Access Compliance Report

| Intersection ID: 16410 | Main Street: BISHOP_DR | Cross Street: PRESSLEY_RD | Location: SE |
| ADA ID: EE5BB62F63C6 | Ramp Type: PerpDiag | Initial Pass/Fail: Fail | Overall Compliance: No |

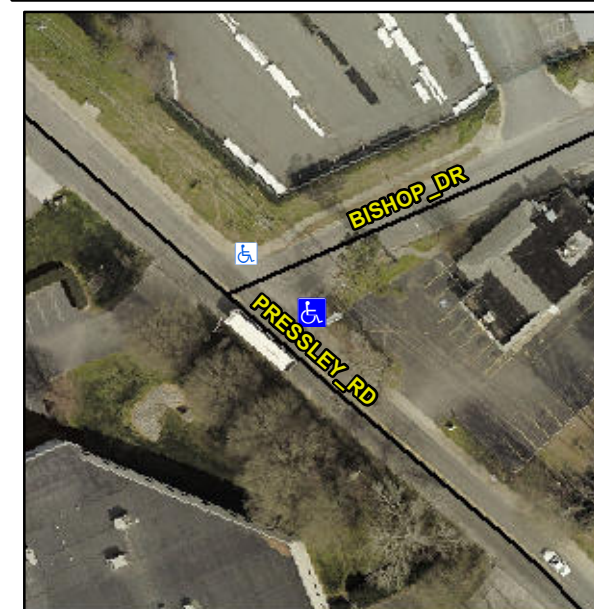
R304.2.2, R304.5.3

| Compliance | Description | Data | Compliance | Description | Data |
|------------|-----------------------|-------|------------|-----------------------------|------|
| N/A | Ramp Length (in) | 45.0 | No | Ramp Slope (%) | 10.8 |
| Yes | Ramp Width (in) | 48.0 | No | Ramp XSlope (%) | 4.2 |

Remove & Replace Curb Ramp With Two New Directional Ramps or Equivalent.
